How to update T26SZ

This software updates or alters the functions and features noted below. The instructions and information that follow are meant as a supplement to the original instruction manual that accompanied the T26SZ transmitter. Please refer to the original instruction manual where applicable, but replace the steps indicated below with these instructions. Please check to ensure that the update has been installed.

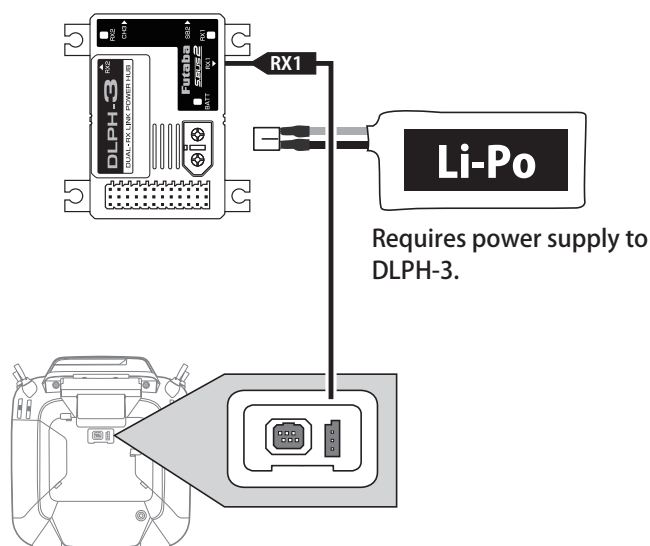
Added Vector Nozzle function for jet models.

Camber mixing setting rate has been expanded from ± 100 to ± 200 .

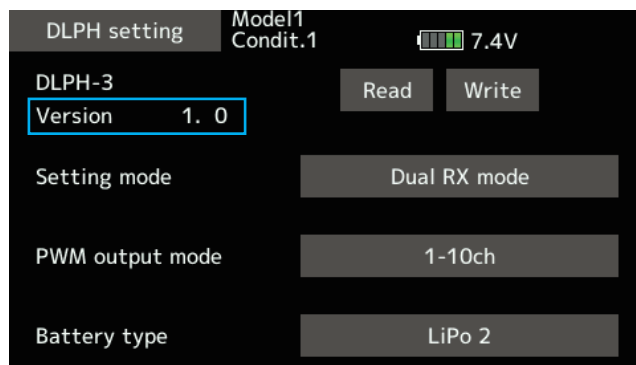
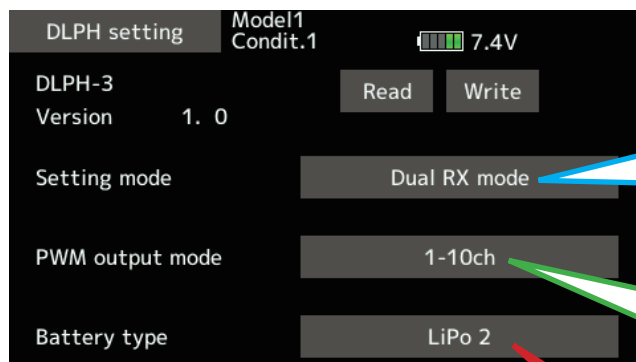
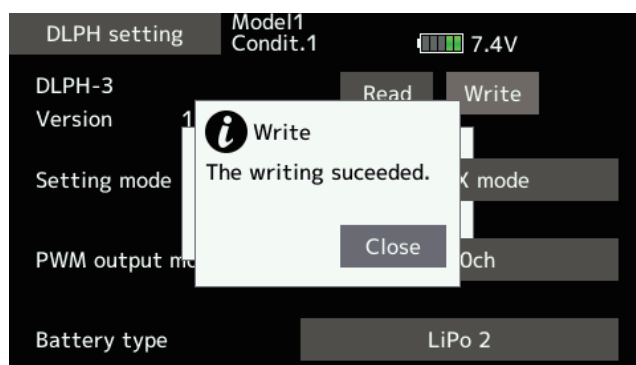
3. Now compatible with Power Hub DLPH-3.

By connecting the DLPH-3 to the transmitter, it is possible to change the mode of the DLPH-3.

⑤ Set the mode of the DLPH-3.
